RAPIER AVENUE SUBDIVISION

Revised for the January 6, 2022 meeting:

APPLICATION NUMBER ____1 DATE __January 6, 2022

DETAIL SITE PLAN

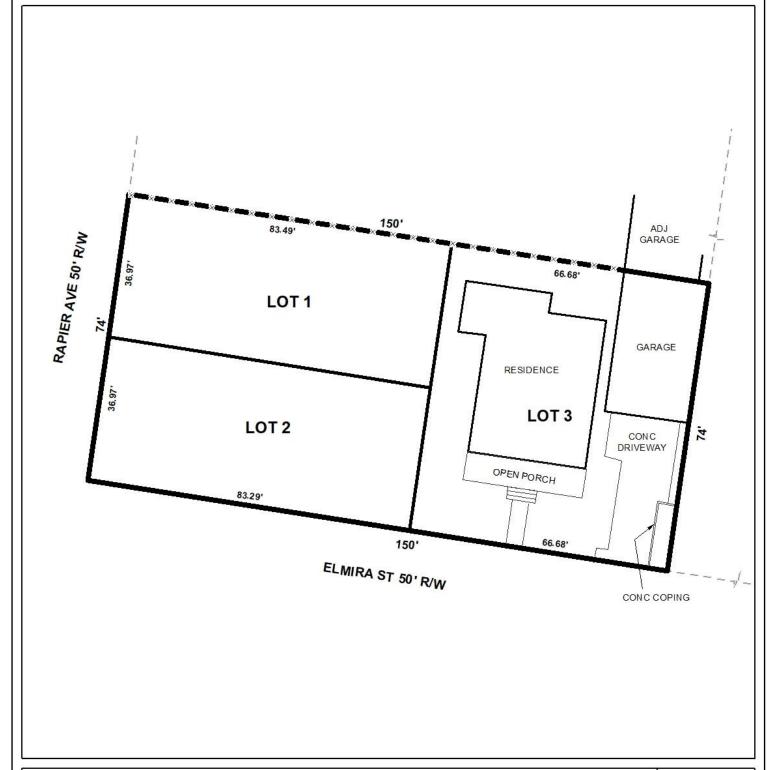
- B. Review and revise the last distance call-out on the south boundary of the proposed subdivision.
- C. Provide the Surveyor's and Owner's (notarized) signatures.

Furthermore, the proposed subdivision will result in Lots 1 and 2 having 36.97 feet of frontage along Rapier Avenue, and proposed Lot 3 having 66.68 feet of frontage along Elmira Street. Lot 1 would have 3,091 square feet; Lot 2 would have 3,081 square feet; and Lot 3 would have 4,946 square feet. Lots 1 and 2 would not meet the minimum width requirement (60-foot width at the building setback line), and none of the three would meet the minimum area requirement of 7,200 square feet of Section V.D.2. of the Subdivision Regulations. Given that the site is in the Oakleigh Garden Historic District, substandard size lots are common, and the Commission has approved other small-lot subdivisions within the area. However, those subdivisions were in instances where dwellings already existed on the proposed lots, and the subdivisions were intended to provide a separate lot of record for an existing dwelling, even though the lots were of substandard size. In this instance, the lot size for the existing dwelling would be reduced from a compliant size to a noncompliant size, and all three proposed lots would be of substandard size and would be in violation of both the Zoning Ordinance and Subdivision Regulations.
